## INY4 M25B

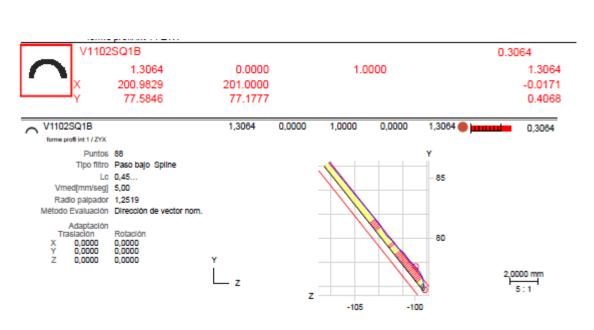
## **CAMBIAR PIN**

Q	1022L1Z 133.3583 coord Z 1022	134.0000	134.6000	133.4000	-0.0417 -0.6417
---	-------------------------------------	----------	----------	----------	--------------------

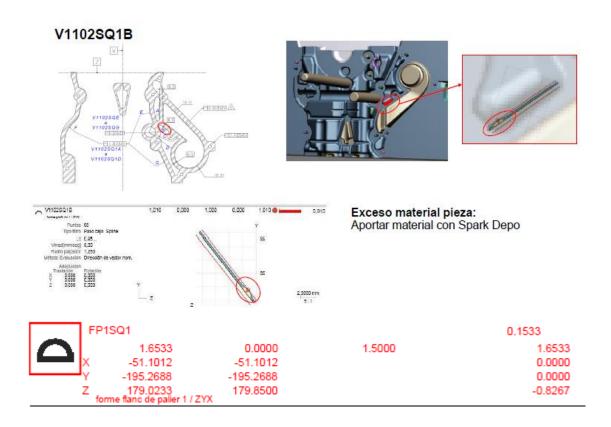
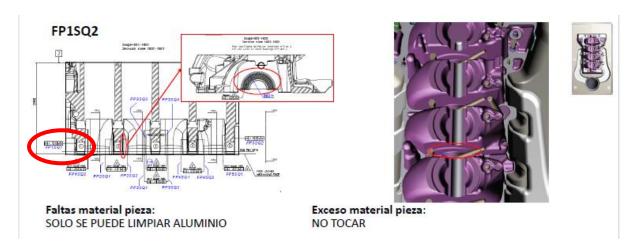
## CAMBIAR PIN Y RETOCAR LA ZONA DEL LAMADO EN EL MOLDE, FALTA MATERIAL EN LA PIEZA

Q	3072L1Z 186.1497 coord Z 3072	187.0000	187.8000	186.2000	-0.0503 -0.8503
Ф	3072L1 1.7420 Y 42.1888 Z -186.1497 loc 3072 / ZY (7,58)	0.0000 42.0000 -187.0000	1.6000		0.1420 1.7420 0.1888 0.8503
Q	3072L2 182.0609 loc face 3072 / X	183,3000	183.9000	182.7000	-0.6391 -1.2391

ES LA ZONA MARCADA EN EL OVALO ROJO
